MODIFICATION RECOMMENDED

N5241AS-02A

S E R V I C E N O T E

N5241AS PNA Series Microwave Network Analyzers

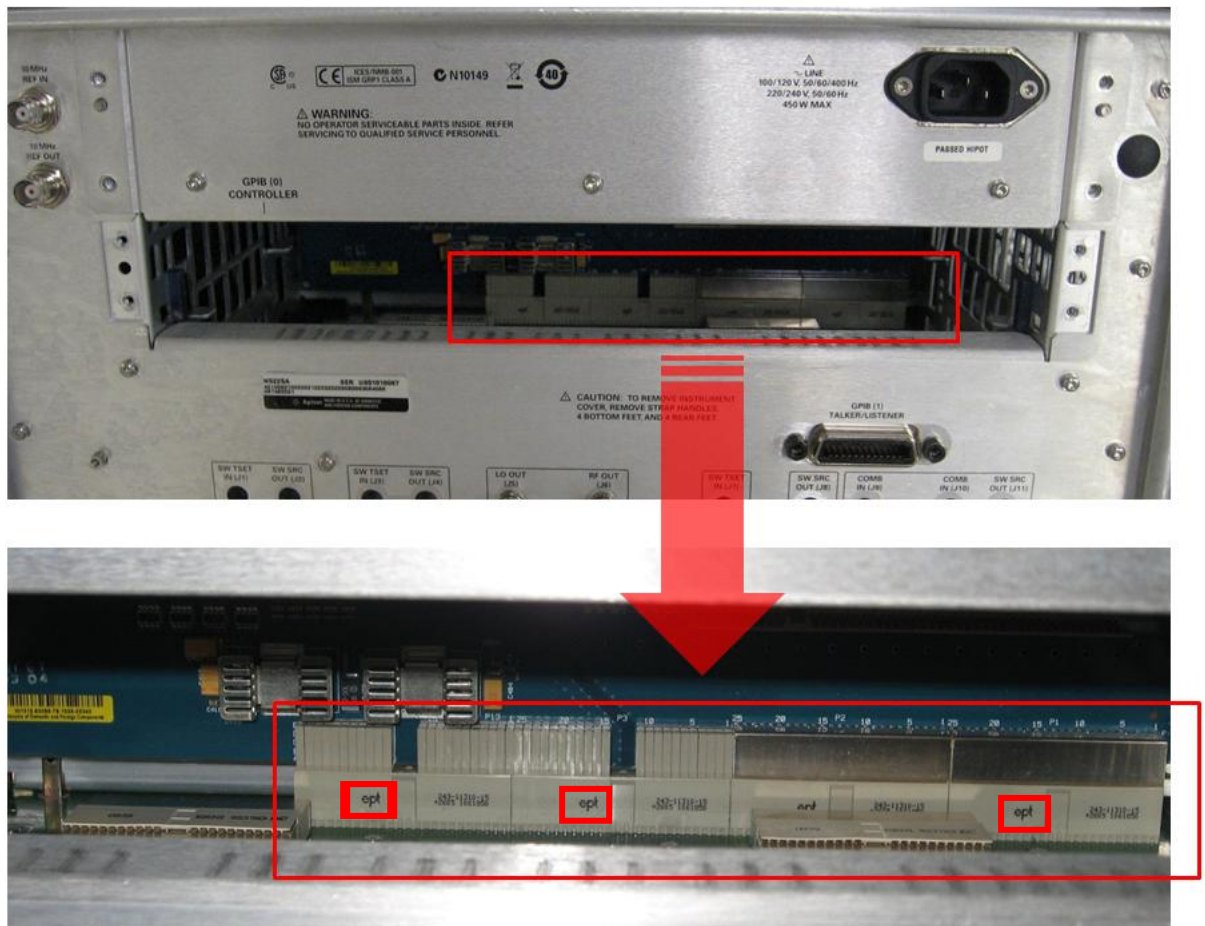
1. Remove the CPU assembly from the analyzer's rear panel. Refer to the PNA Service Guide chapter 7 section titled, "Removing and Replacing the CPU Board Assembly" for removal and reinstallation procedures. To view the online Service Guide, see the numbered list on the next page for instructions.
2. As per the photo below, inspect the system motherboard connector to see if it has one or more "ept" logos.

3. If the connector has one or more “ept” logos, return the analyzer to Agilent for replacement of the system motherboard. If the connector does not have one or more “ept” logos, email ctd-soco_support@agilent.com, providing the analyzer model and serial number and details of the malfunction symptoms.

4. *For Agilent Service Technicians only:* Only new boards without “ept” logos should be installed. Before installing the new board, look to see if it has one or more “ept” logos. If so, email ctd-soco_support@agilent.com, providing the analyzer model and serial number. Wait for further instructions in an email reply. New boards without “ept” logos can be installed. For installation instructions, refer to the PNA Service Guide chapter 7 section titled, “Removing and Replacing the System Motherboard.” To view the online Service Guide, see the numbered list on the next page for instructions.
